Well Name: APRIL SURPRISE	Well Location: T24N / R9W / SEC 30 / SESE / 36.27947 / -107.82224	County or Parish/State: SAN JUAN / NM
Well Number: 8	Type of Well: CONVENTIONAL GAS WELL	Allottee or Tribe Name:
Lease Number: NMNM4958	Unit or CA Name:	Unit or CA Number:
US Well Number: 300452941900S1	Operator: DUGAN PRODUCTION CORPORATION

Notice of Intent

Type of Submission: Notice of Intent	Type of Action: Plug and Abandonment
Date Sundry Submitted: 11/03/2025	Time Sundry Submitted: 10:20
Date proposed operation will begin: 11/14/2025

Notice of Intent – Plug and Abandonment

Planned P & A Schematic

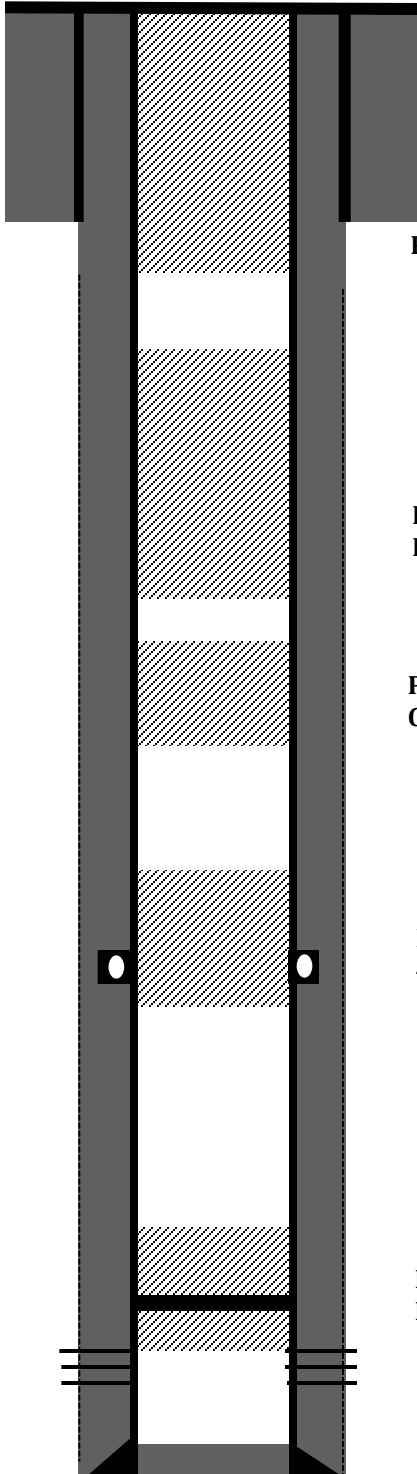
1. Plugging operations authorized are subject to the attached "General Requirements for Permanent Abandonment of Wells on Federal and Indian Lease."
2. The following modifications to your plugging program are to be made:
 - a. Modify Plug 3. Make the TOC 1720' to correspond to the submitted formation top.
 - b. Modify Plug 4. Make the TOC 630' to cover the BLM Geologist's pick for the Ojo Alamo at 737'.
3. **Notification:** Farmington Office is to be notified at least 24 hours before the plugging operations commence at (505) 564 7750.

-Modify Plug 3. Make the TOC 1720' to correspond to the submitted formation top.

Modify Plug 4. Make the TOC 630' to cover the BLM geologist's pick for the Ojo Alamo.
